DESCRIPTIVE REPORT TO ACCOMPANY  
HYDROGRAPHIC SURVEY H-8846  
FIELD NO. WH-12.5-1-65

NORFOLK HYDROGRAPHIC PROCESSING BRANCH  
ADDENDUM  
To Accompany

HYDROGRAPHIC SURVEY H-8846 (Wh 12.5-1-65)

VERIFIER'S REPORT OF HYDROGRAPHIC SURVEY NO. H-8846

Overlay No. 2

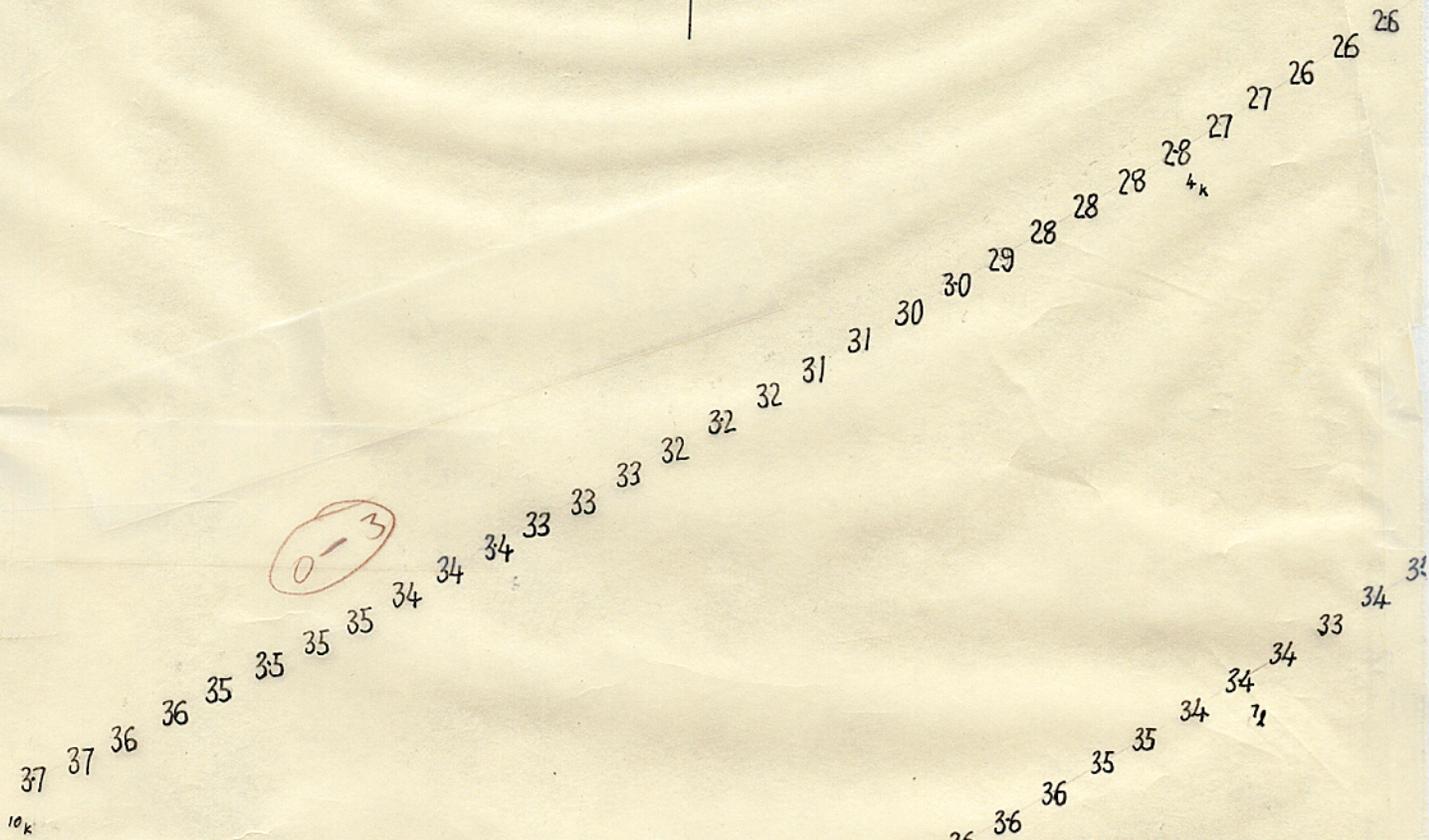
29. All aids located, with those on contemporary topographic sheets, have been shown on survey.
30. Depth curves were satisfactory except as follows:
31. Sounding line crossings were satisfactory except as follows:  
*Discrepancies of one to four feet were noted and plotted on tracing paper overlays No. 1 thru 5. It is believed that a combination of possible erroneous tide corrections and voltage regulation problems on the HIRAN sets as described in "Hiran Report OPR-369-1965" would be the most likely cause of these discrepancies. (blue) 8a-13a, 1x-10x, 1e-11e, 48e-50s, 99f-102s, 150u-152u  
1v-5v, 1x-5x, 47x-49x, 1151a-1171a. (red) 50e-52e*

Pos. 4k-10k  
7e-11e

Overlay No. 3

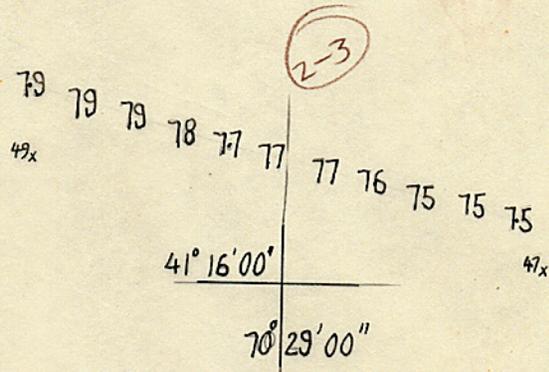
Pos. 47x-49x

Overlay No. 4

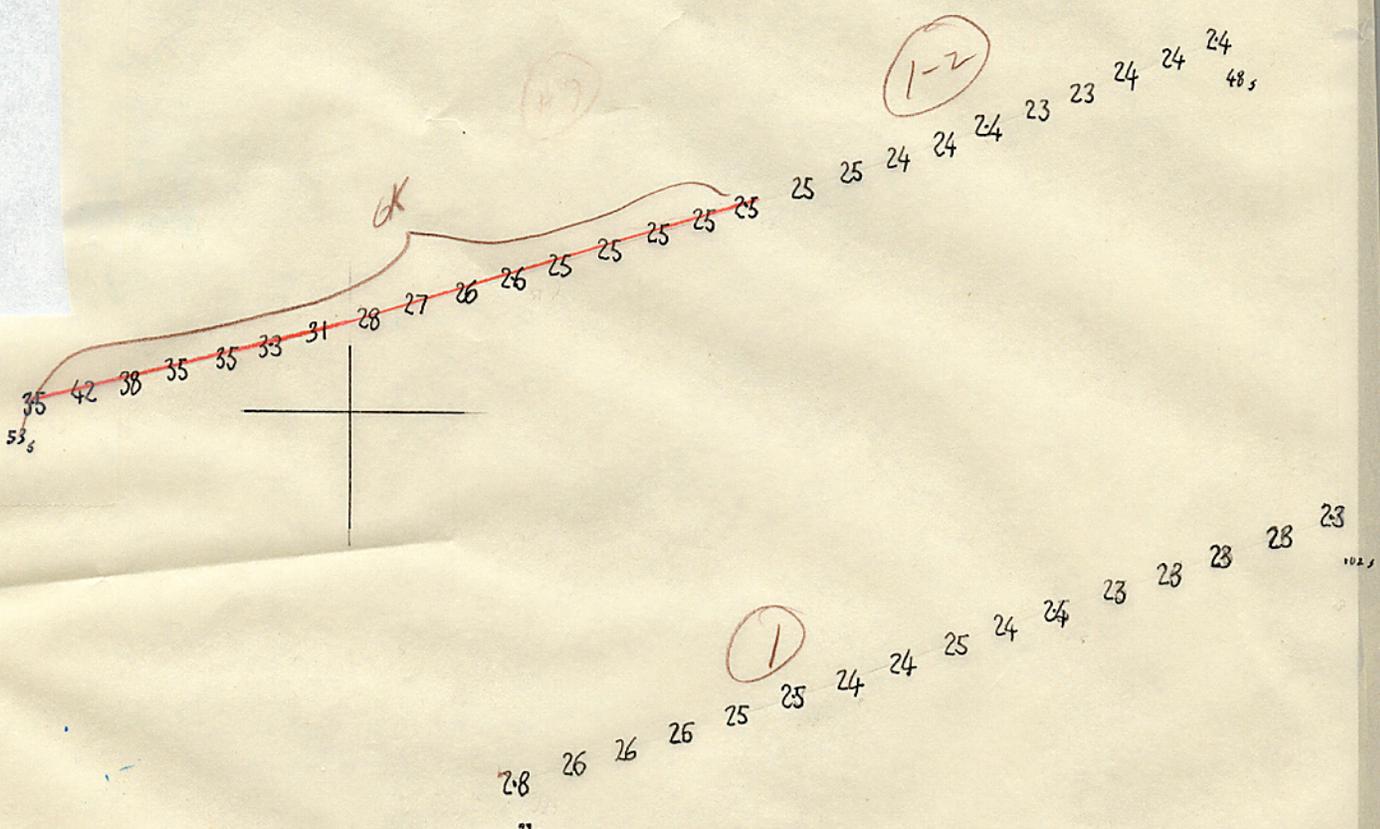
Pos. 48s-53s  
99s-102s
